ADDENDUM NO. 1

DATE: April 26, 2015
PROJECT: Marquette Area Public Schools – 2016 Improvements
OWNER: Marquette Area Public Schools
BID DATE: Tuesday, May 3, 2016 at 10:00 am

The following shall be incorporated into the Contract Documents dated **7 APR 2016**.

SHEET
AD1-E1

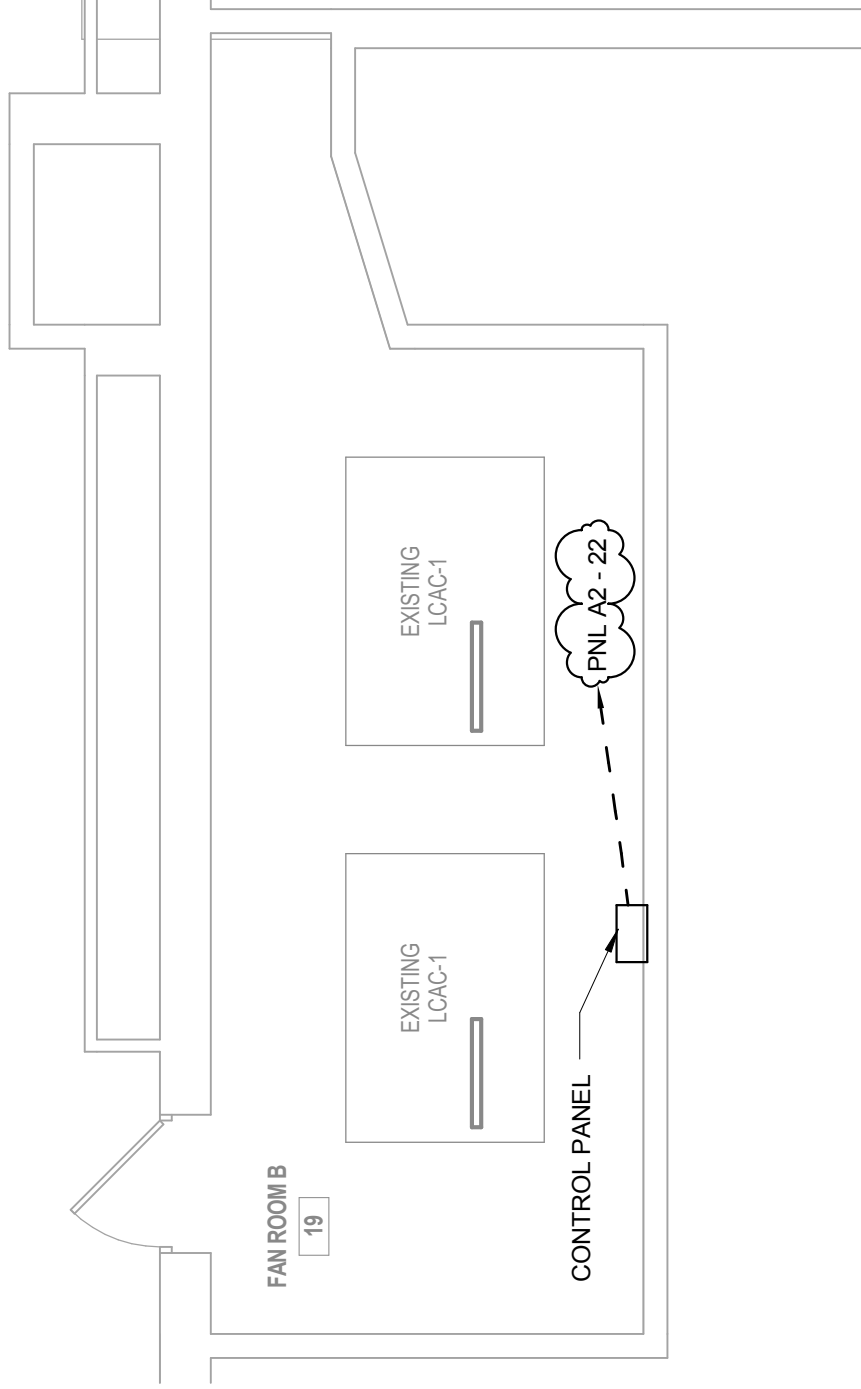
AD1-E1 See circuit for control panel in Fan Room C.
AD1-E2 See circuit for control panel in Fan Room B.
AD1-E3 See circuit for boiler control panel in Boiler Room.
